Access Compliance Report

Public Rights-of-Way

| Intersection ID: 4679 | Main Street: HERITAGE_POINTE_RD | Cross Street: US_29_ACCESS_RD | Location: W |
| ADA ID: 5A718368DA59 | Ramp Type: Perp | Initial Pass/Fail: Fail | Overall Compliance: No |

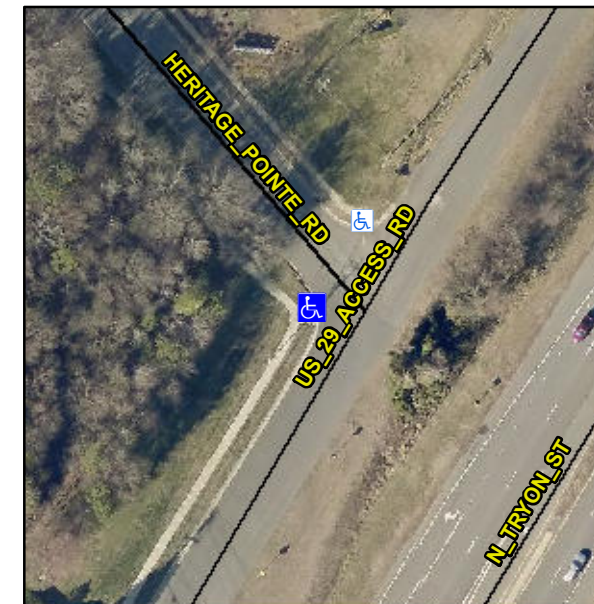
R304.5.1, R304.2.2

| Compliance | Description | Data | Compliance | Description | Data |
|------------|-----------------------|-------|------------|-----------------------------|------|
| N/A | Ramp Length (in) | 98.0 | No | Ramp Slope (%) | 8.6 |
| No | Ramp Width (in) | 39.0 | Yes | Ramp XSlope (%) | 0.4 |

Remove & Replace Entire Ramp.
